Access Compliance Report

Public Rights-of-Way

(Curb Ramps)

Intersection ID: 17480	Main Street: MIDDLEBURG_DR	Cross Street: CITY_VIEW_DR	Location: NE
ADA ID: 0152602640C1	Ramp Type: PerpDiag	Initial Pass/Fail: Fail	Overall Compliance: No
Severity Score: 25			
Codes/Mitigation Info/Possible Solution		Field Measurements/Component Compliance

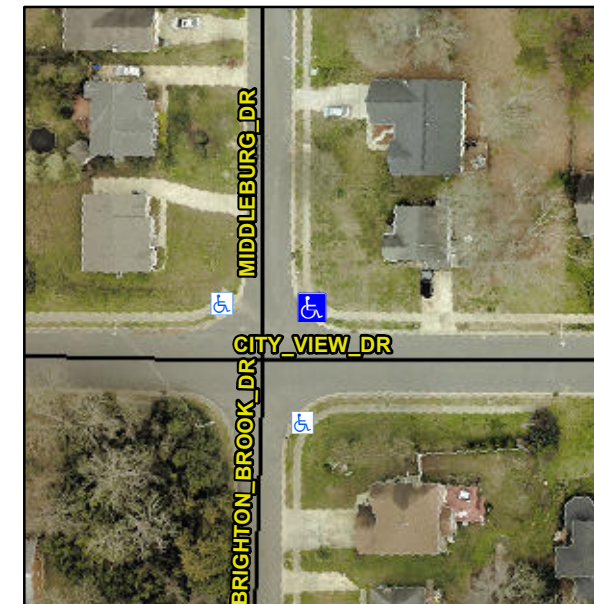
R304.5.3

Compliance	Description	Data	Compliance	Description	Data
N/A	Ramp Length (in)	95.0	Yes	Ramp Slope (%)	5.6
Yes	Ramp Width (in)	48.0	No	Ramp XSlope (%)	7.9
N/A	Flare Type LT	N/A	N/A	Flare Type RT	N/A
N/A	Flare Slope LT (%)	N/A	N/A	Flare Slope RT (%)	N/A
N/A	Flare Traversable LT?	N/A	N/A	Flare Traversable RT?	N/A
N/A	Landing Length (in)	N/A	N/A	DWS Provided?	N/A
N/A	Landing Width (in)	N/A	N/A	DWS Contrast?	N/A
N/A	Landing Slope (%)	N/A	N/A	DWS Length (in)	N/A
N/A	Landing X Slope (%)	N/A	N/A	DWS Full Width?	N/A
N/A	Landing Curb? (Y/N)	N/A	N/A	DWS Offset (in)	N/A
N/A	Shared Landing?	N/A			
N/A	Gutter Ponding?	N/A	N/A	Gutter Slope (%)	N/A
N/A	Gutter Lip Ht (in)	N/A	N/A	Gutter X Slope (%)	N/A
N/A	Painted X Walk1?	No	N/A	Painted X Walk2?	No
	X Walk 1 Direction	To NW		X Walk 2 Direction	To SW
N/A	X Walk 1 Width (in)	N/A	N/A	X Walk 2 Width (in)	N/A
	X Walk 1 Slope (%)	4.2		X Walk 2 Slope (%)	6.8
	X Walk 1 X Slope (%)	4.7		X Walk 2 X Slope (%)	4.0

Remove & Replace Curb Ramp With Two New Directional Ramps or Equivalent.
